# ***SERVICE PROCEDURE***

**G-10503  
FEBRUARY 2010**

**SUBJECT: SAFETY RECALL  
ROLL STABILITY CONTROL (RSC) SYSTEM on  
certain ProStar and LoneStar models built 10/7/08  
thru 10/28/09.**

### Correct Air Line Porting

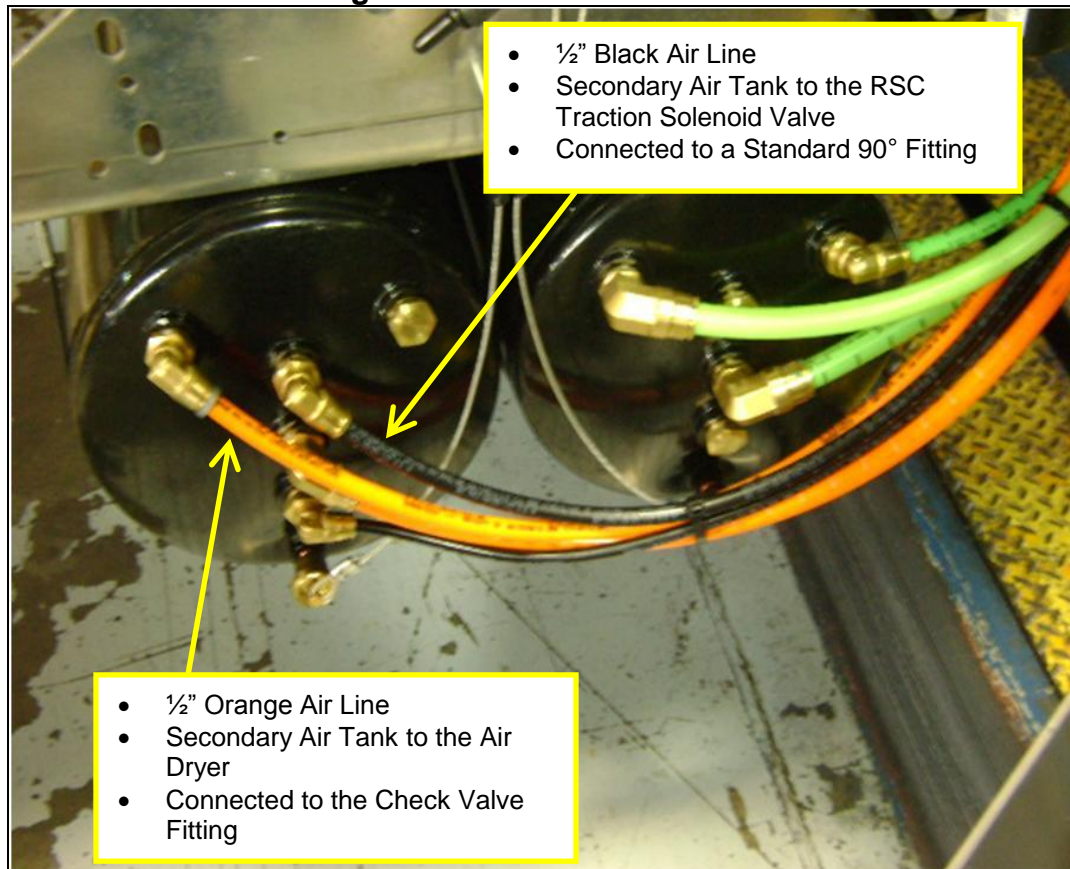
The air line that supplies the traction solenoid valve of the roll stability control (RSC) system may have been connected to an incorrect port on the air tank. This condition at no time affects the normal operation of the tractor and trailer service brakes when activated by the driver, or the function of the tractor RSC system. Less than optimal RSC control of the trailer brakes during a roll stability event may increase the chances of a crash which can result in property damage, personal injury, or death.

1. Overview: When the suspect vehicles were built, the correct porting locations of two air lines may have been reversed at the secondary air tank. This procedure includes inspection for this condition and repair when necessary.
2. Determine if the air line porting on the two air lines noted in the picture below is correct. The orange 1/2" air line should be connected to the 90° fitting as shown. This fitting has an internal one way check valve and can be identified by the grey colored release button where the line enters the fitting. The 1/2" black line should be connected to a similar looking fitting as shown, however, the disconnect release button is brass colored.

3. If the air line porting is correct, no repair is required and the service procedure is complete.
4. If the air line porting is not correct, first deplete air pressure then switch the black and orange air lines at the tank fittings. Do not switch the 90° tank fittings, just the air lines. These fittings must remain in these locations to aid in identification of proper installation. Tie straps on the air line bundle may need to be cut to allow for enough air line length to switch the lines. After switching the lines, replace any ties straps that were removed.
